## ***Interactive comment on “The CO5 configuration of the 7 km Atlantic Margin Model: Large scale biases and sensitivity to forcing, physics options and vertical resolution” by Enda O’Dea et al.***

**Enda O’Dea et al.**

Received and published: 20 April 2017

**Fig. 1.**

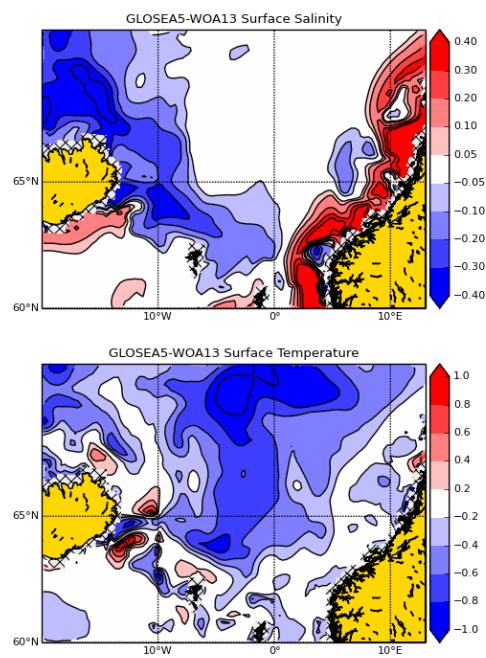
16) p22.l21-23: Give a reference for the cold/fresh bias in ORCA025.

Instead we can compare the GLOSEA data against WOA data as was done with CO5 to show the biases in this region and reword to reference the additional figure attached.
